## **Greensmaster<sup>®</sup> 800, 1000, and 1600 Products**

## Subject: Fuel Tank Leaks at Seam.

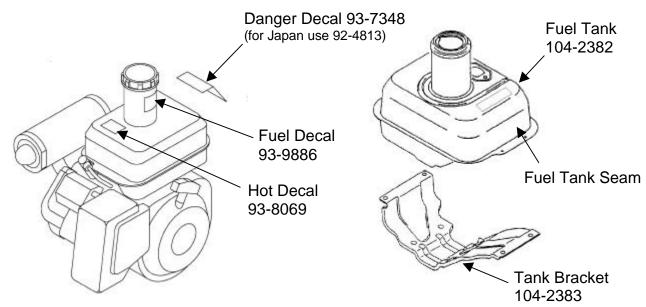
In rare instances, combinations of engine operating speed, conditions, engine performance characteristics, and other elements may contribute to the separation of the Fuel Tank welded seam. Replacement Fuel Tank (104-2382) is now produced using a thicker material to resist these effects. Should this type of failure occur, it is also recommended to install Tank Bracket (104-2383) in place of the existing mounting bracket. This improved bracket is specifically designed to counter the combined effects that can cause this uncommon condition. Several decals are also needed to complete the Fuel Tank assembly.
